BRIDGE REPLACEMENT - CCS LETTING DATE
BRF-065-8(57)--38-17

BRIDGE REPLACEMENT - CCS
US65 OVER EAST BRANCH BEAVERDAM CREEK

FIELD EXAM PLANS

QUESTIONS & COMMENTS

TYPICAL BERM ARMORING DETAIL

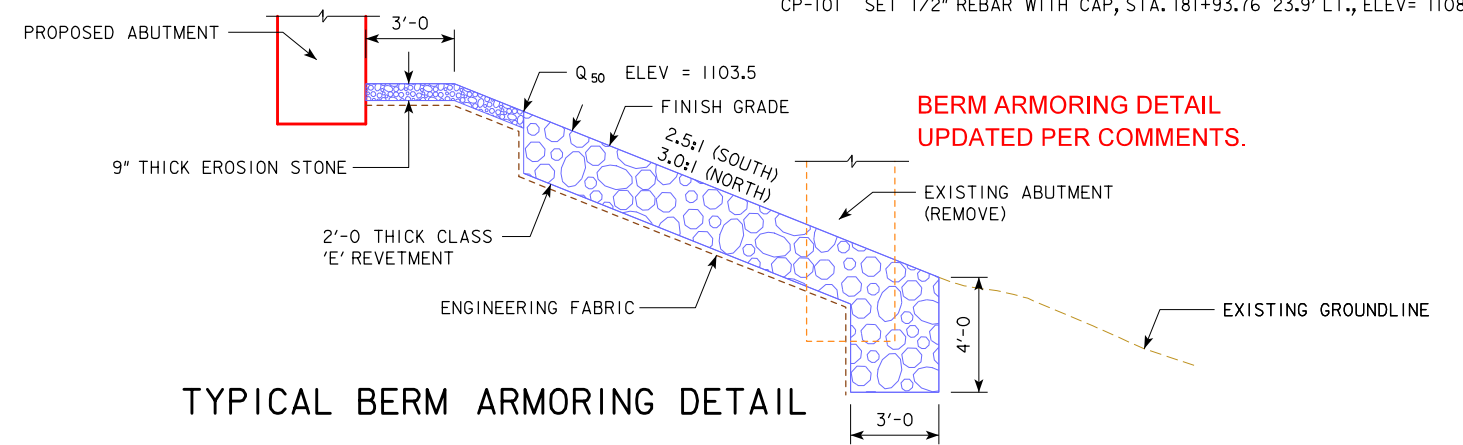
REVETMENT HAS BEEN UPDATED PER PATRICIA SCHWARZ COMMENTS.

SPOT ELEVATIONS ADDED PER PATRICIA SCHWARZ COMMENTS.

SITE PLAN

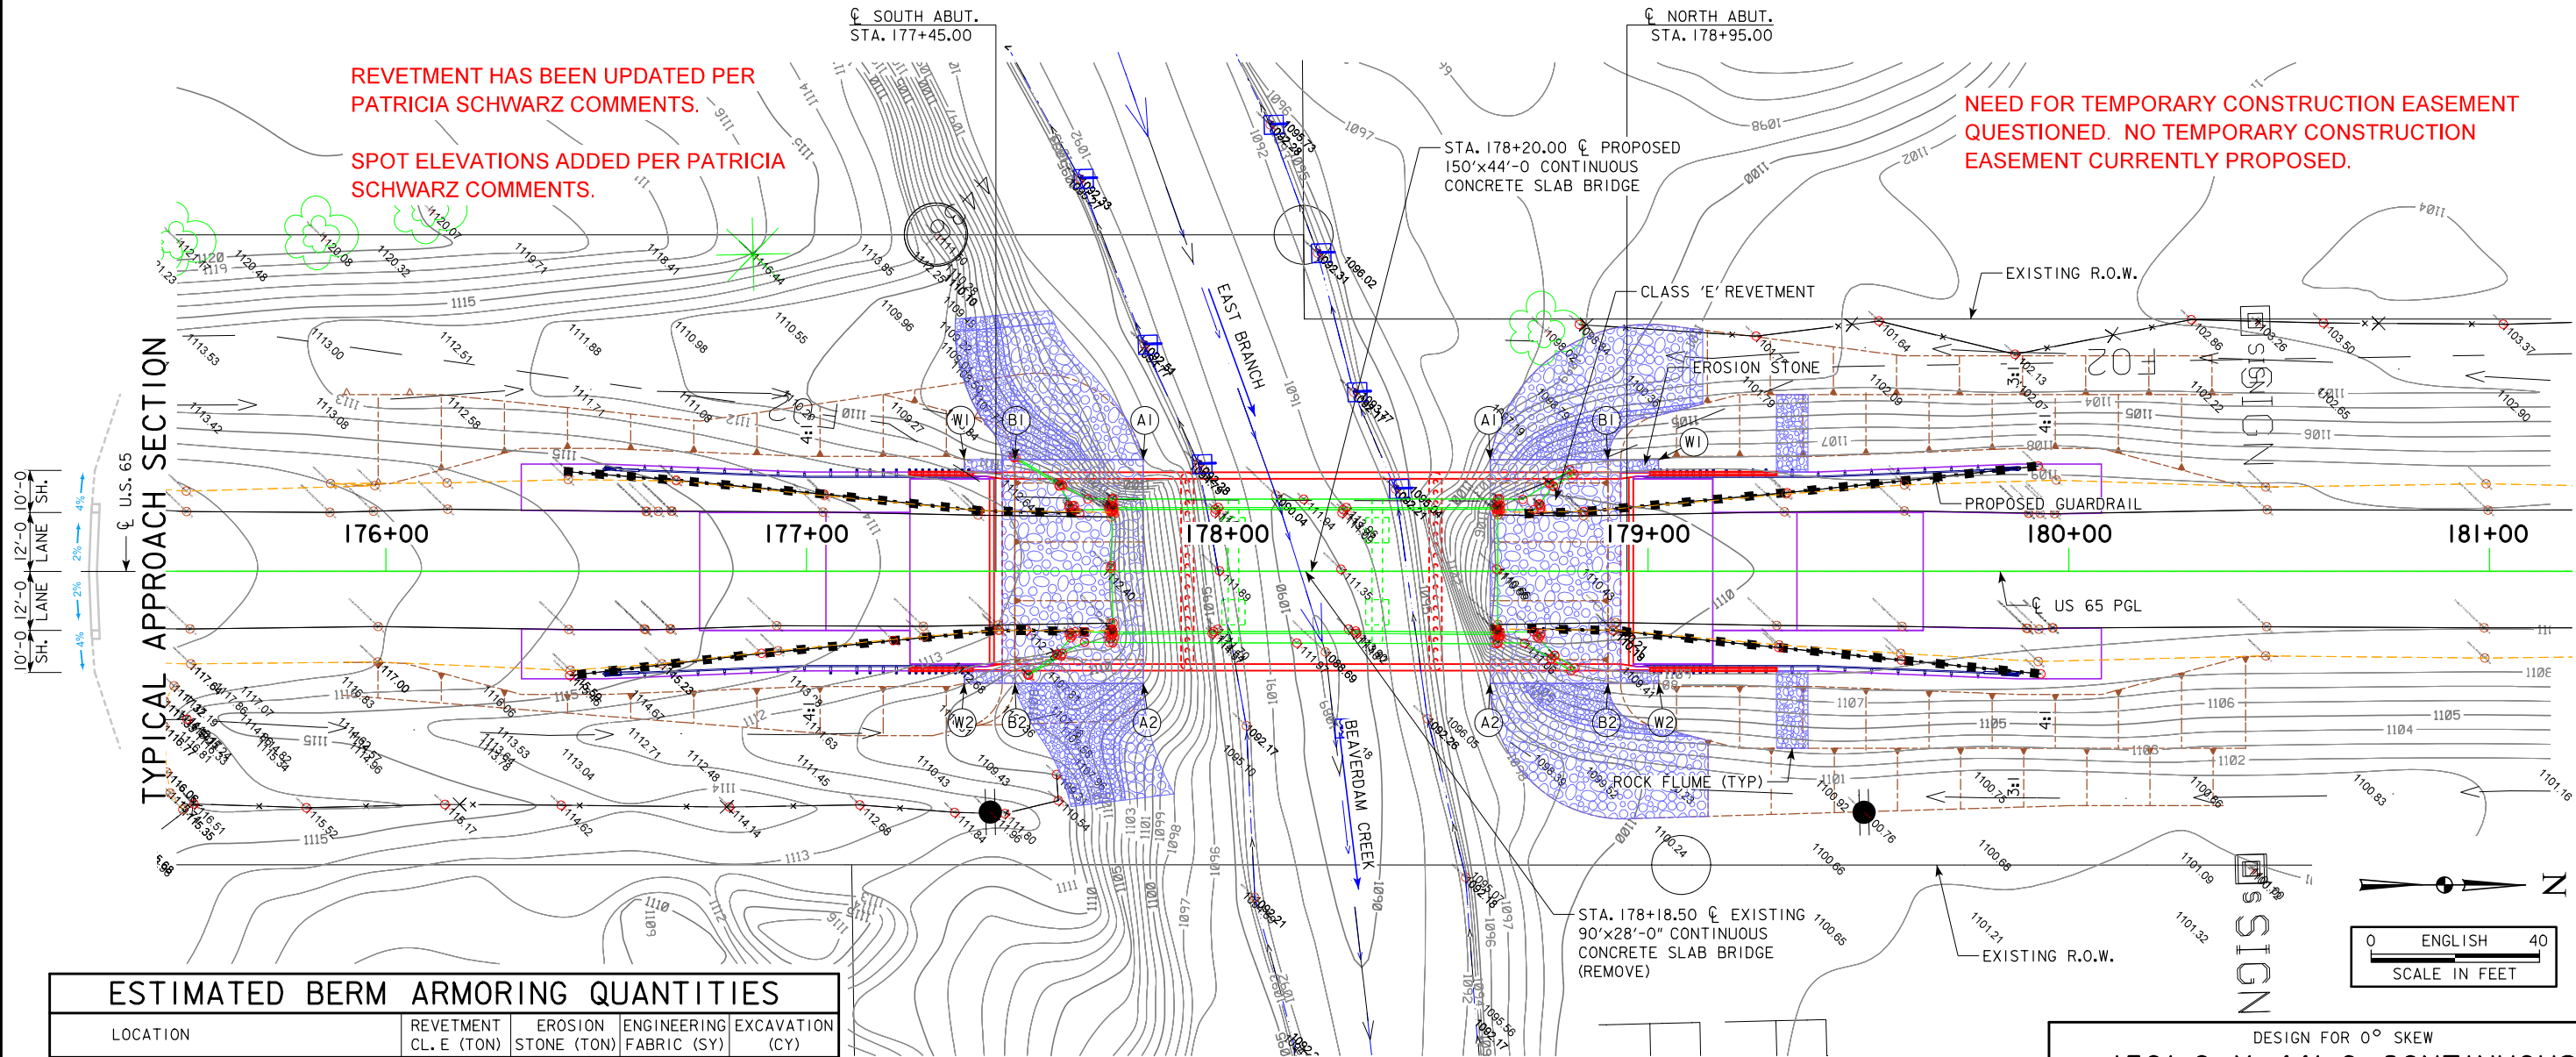
NEED FOR TEMPORARY CONSTRUCTION EASEMENT QUESTIONED. NO TEMPORARY CONSTRUCTION EASEMENT CURRENTLY PROPOSED.

US 65 Preliminary

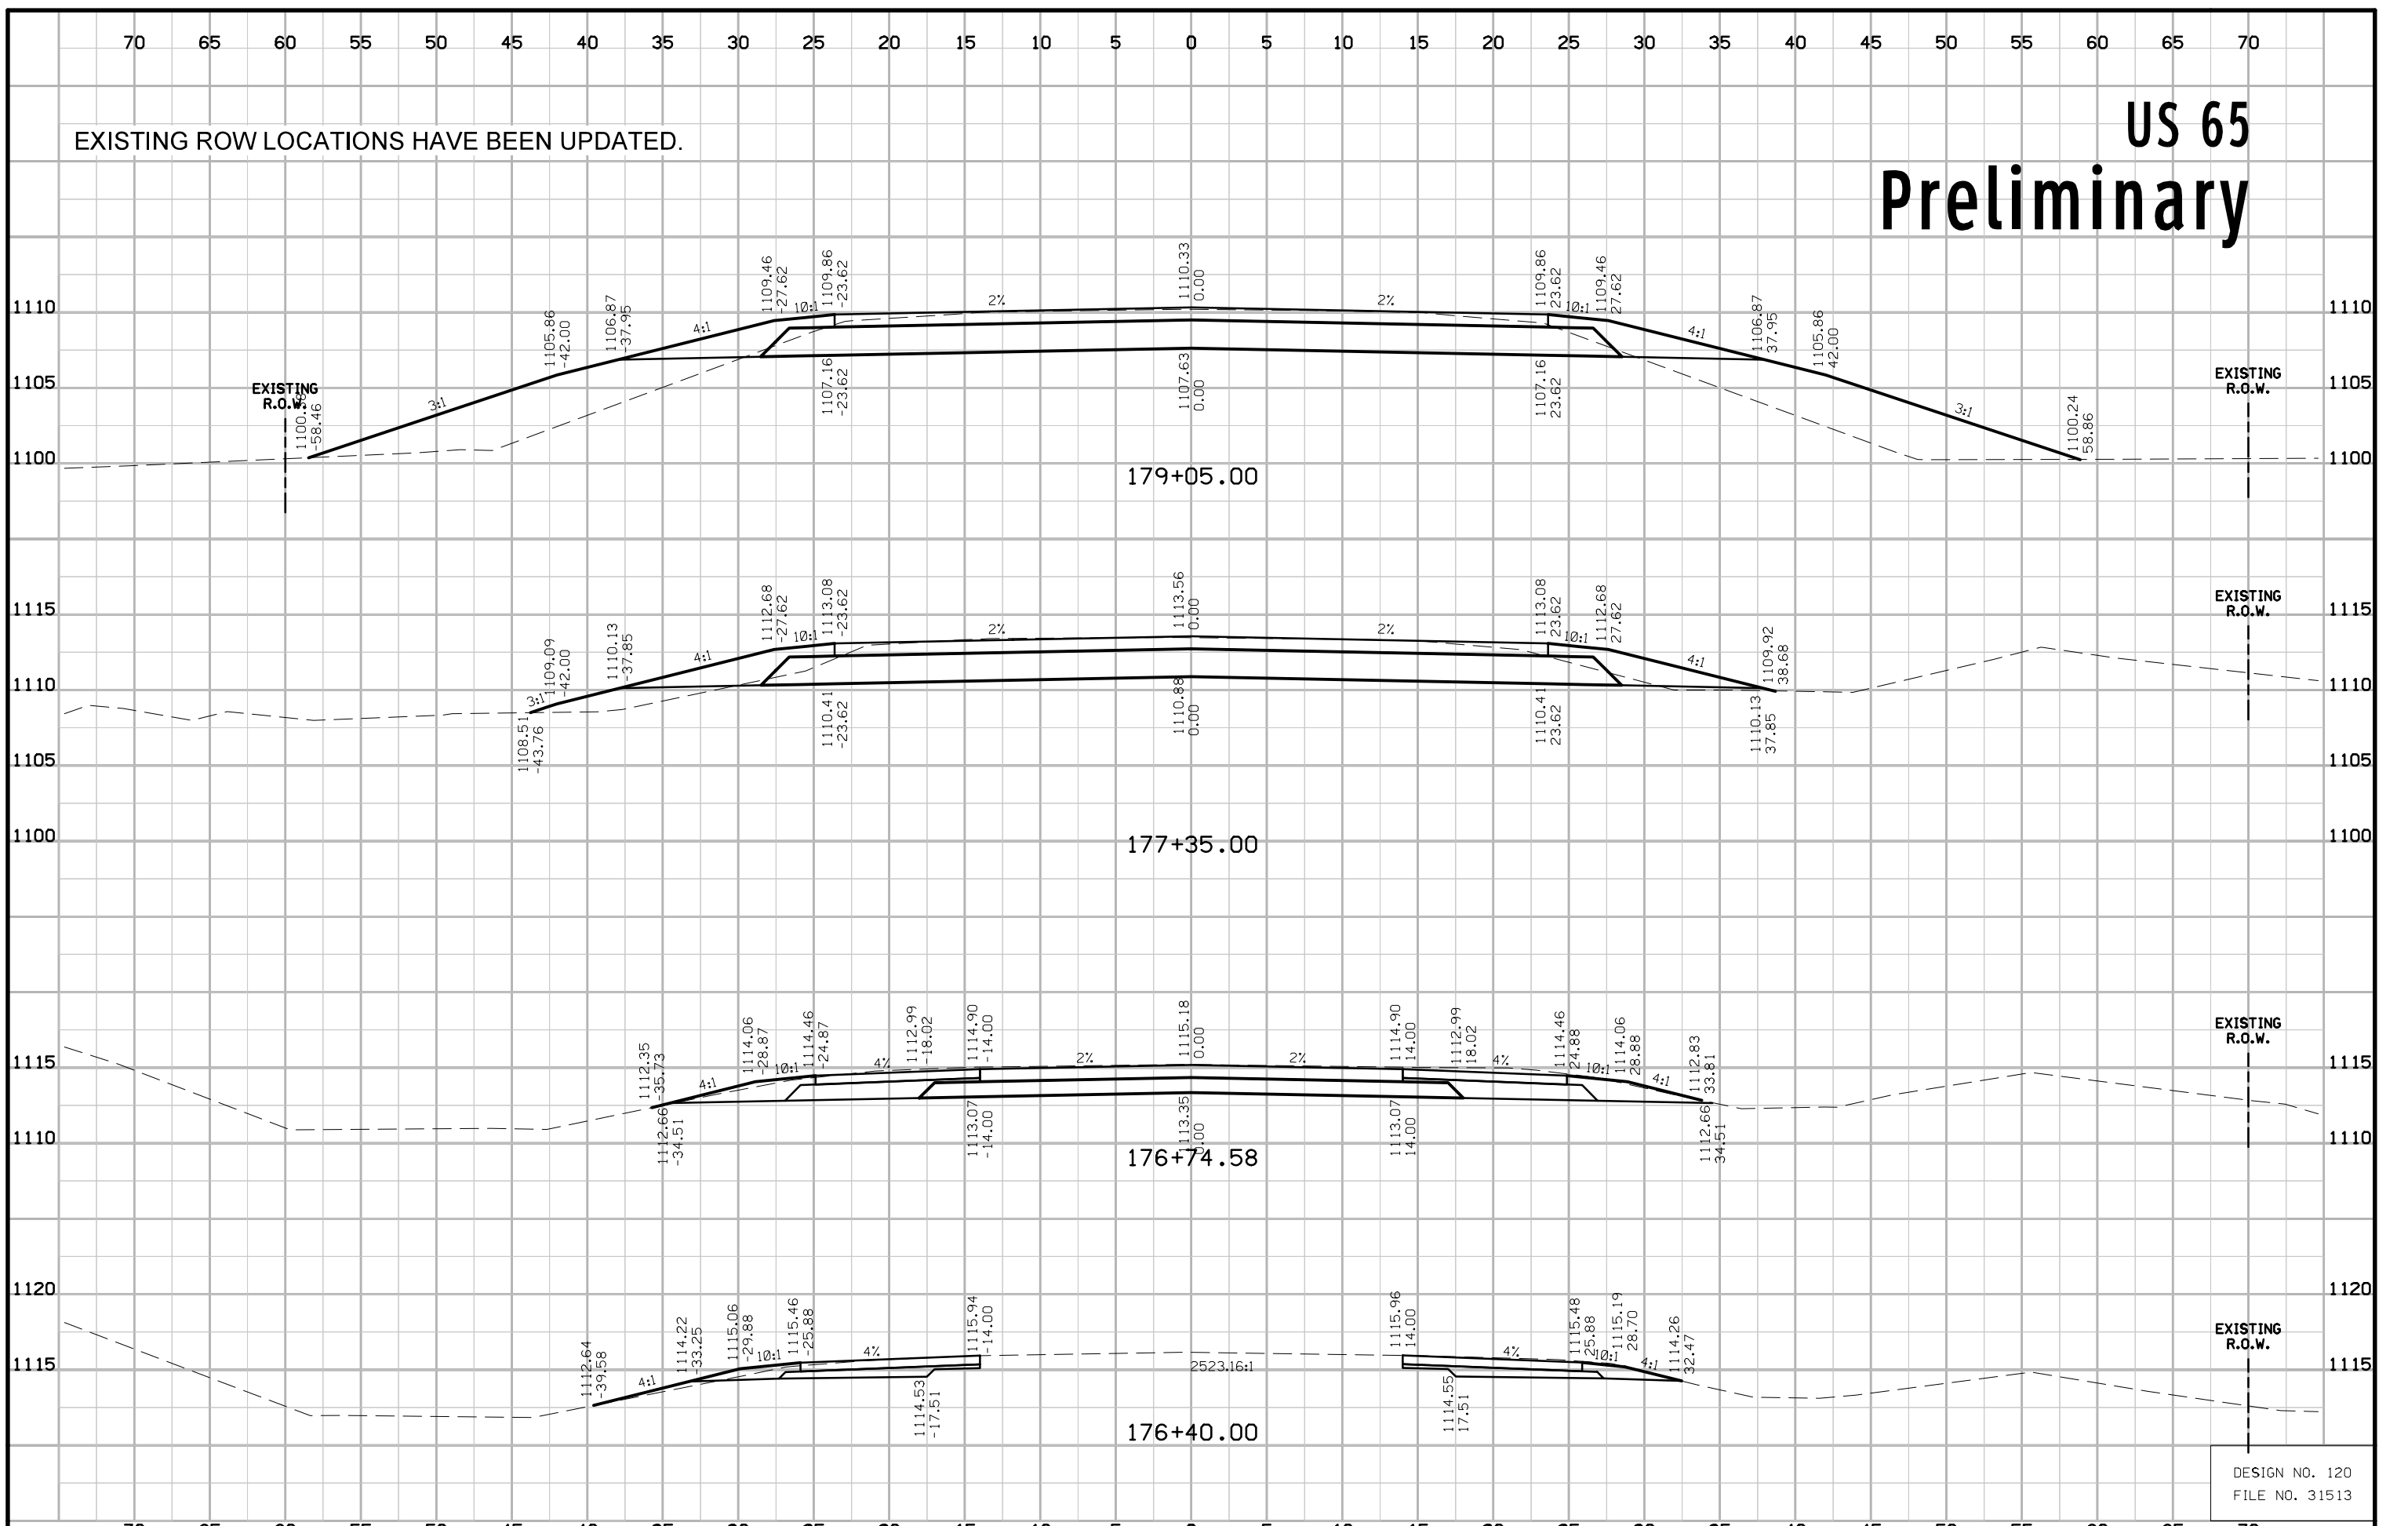
EXISTING ROW LOCATIONS HAVE BEEN UPDATED.

US 65 Preliminary

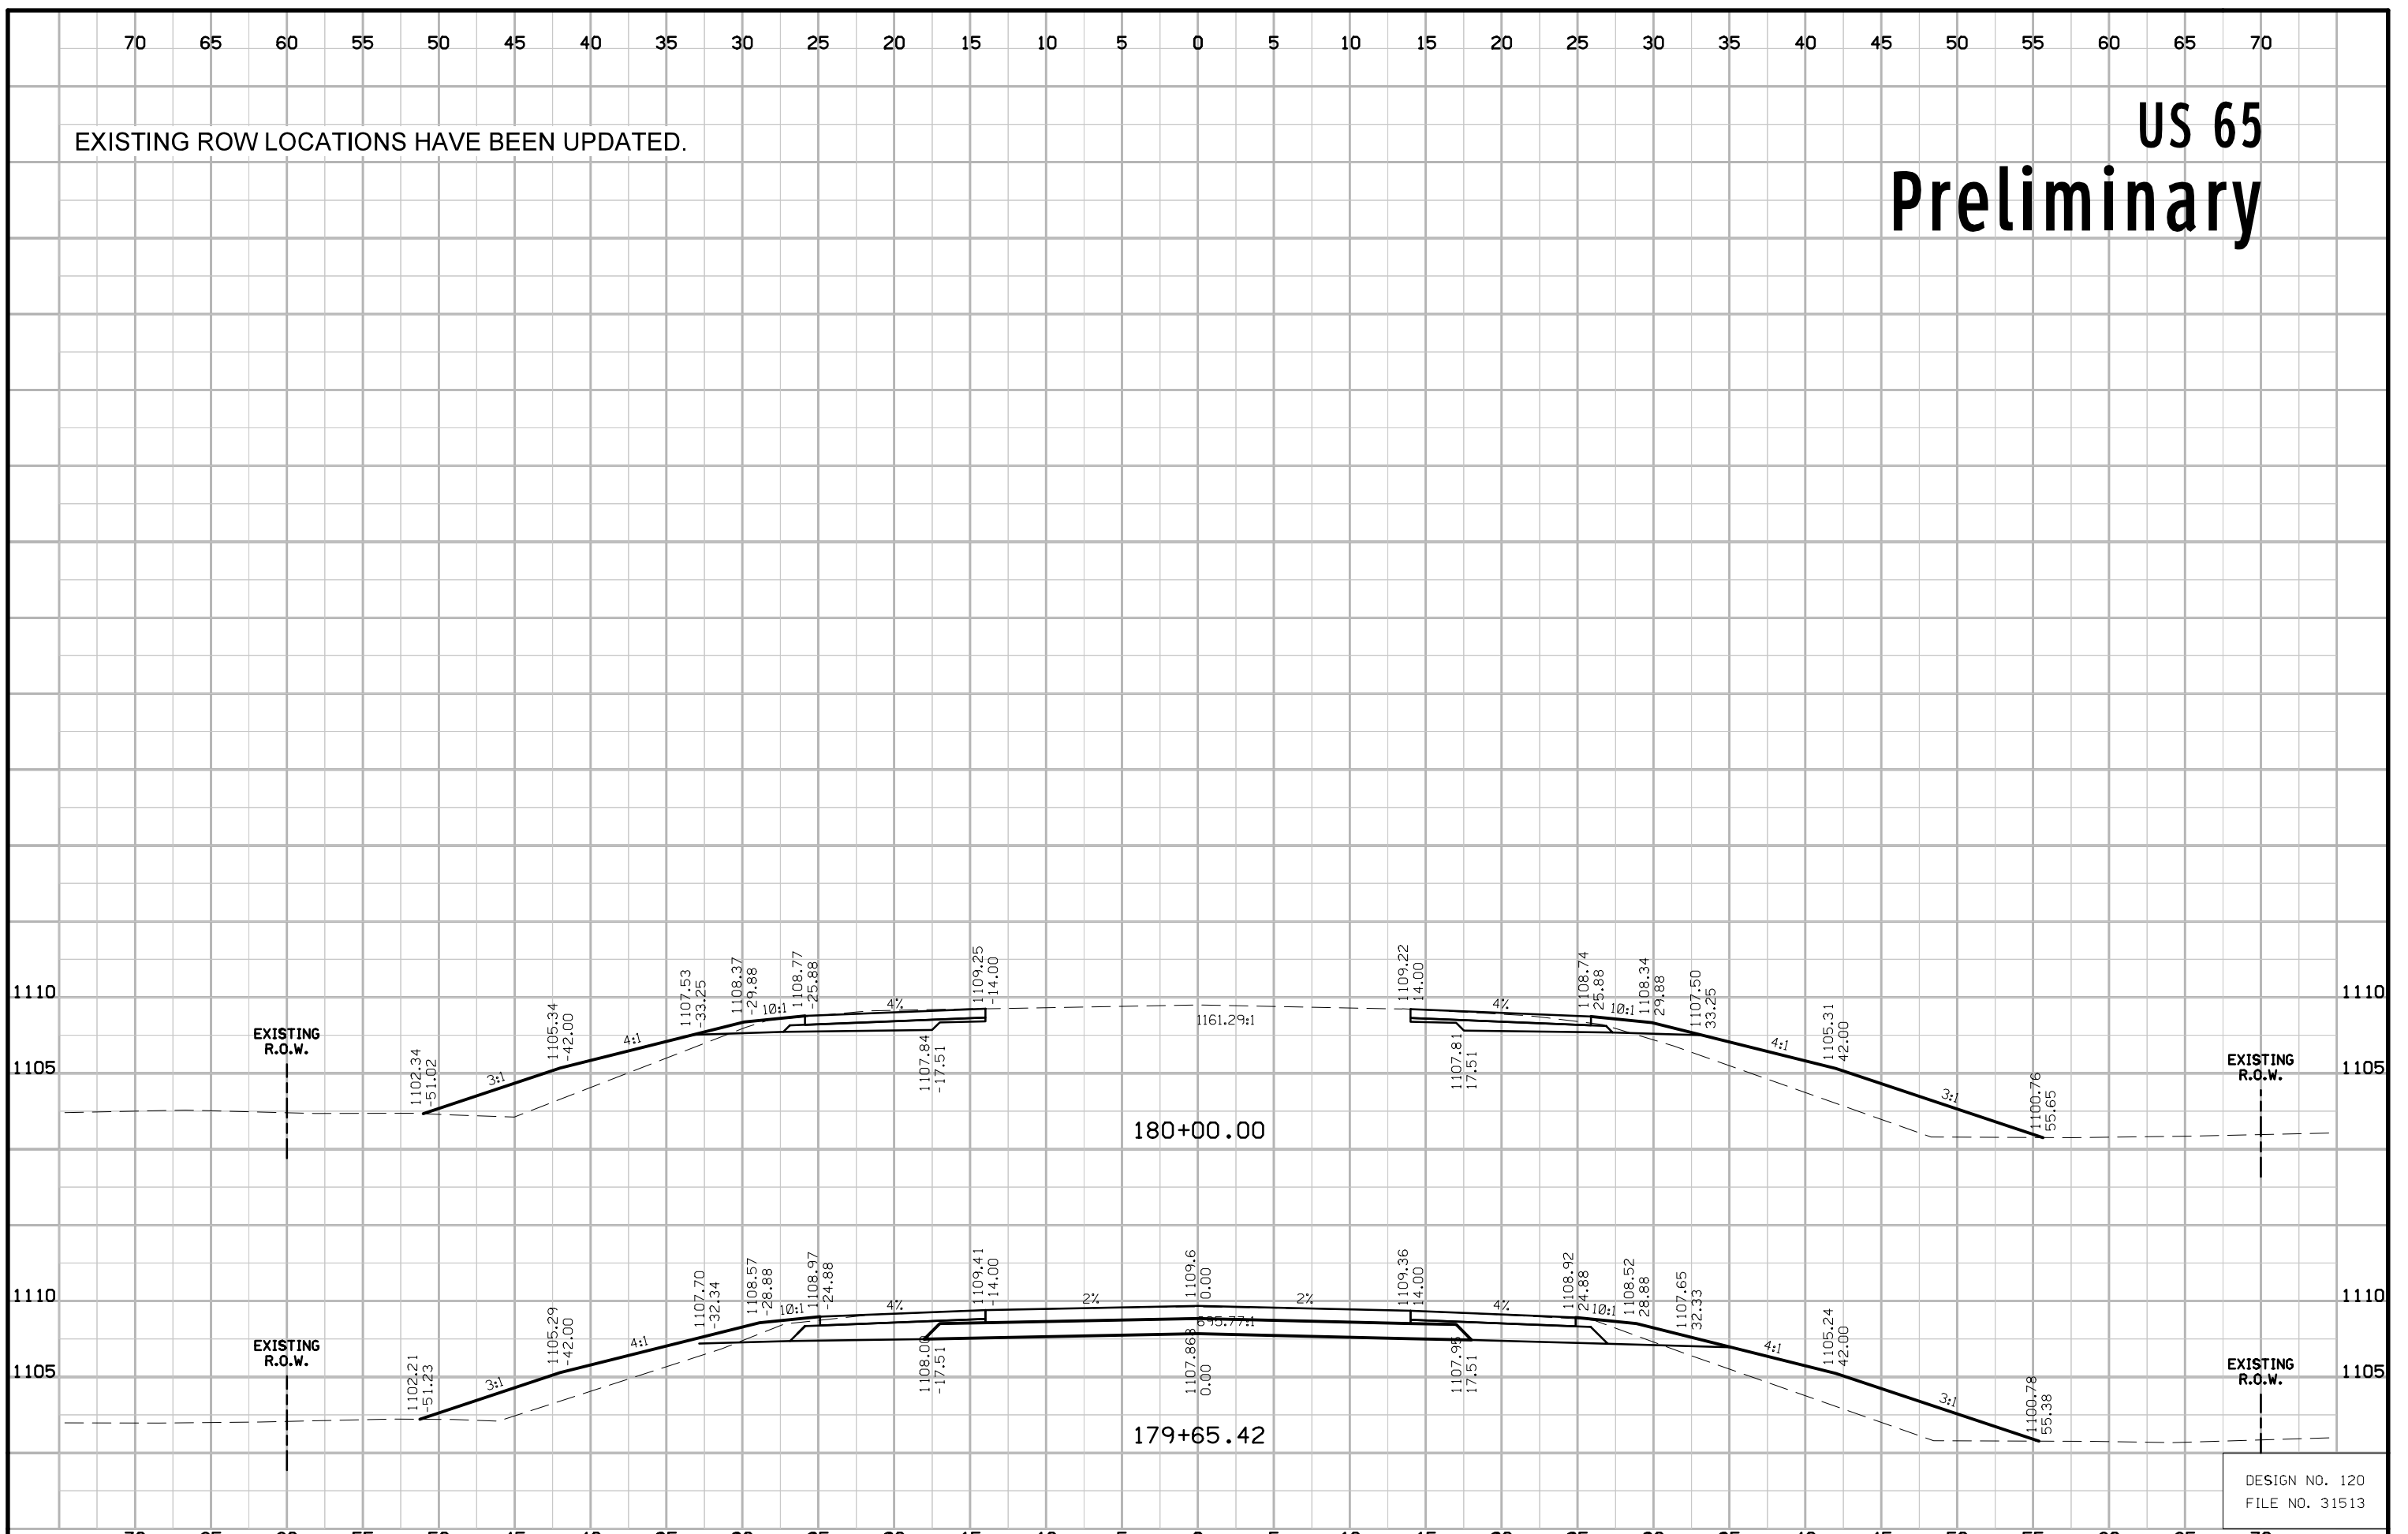
EXISTING ROW LOCATIONS HAVE BEEN UPDATED.
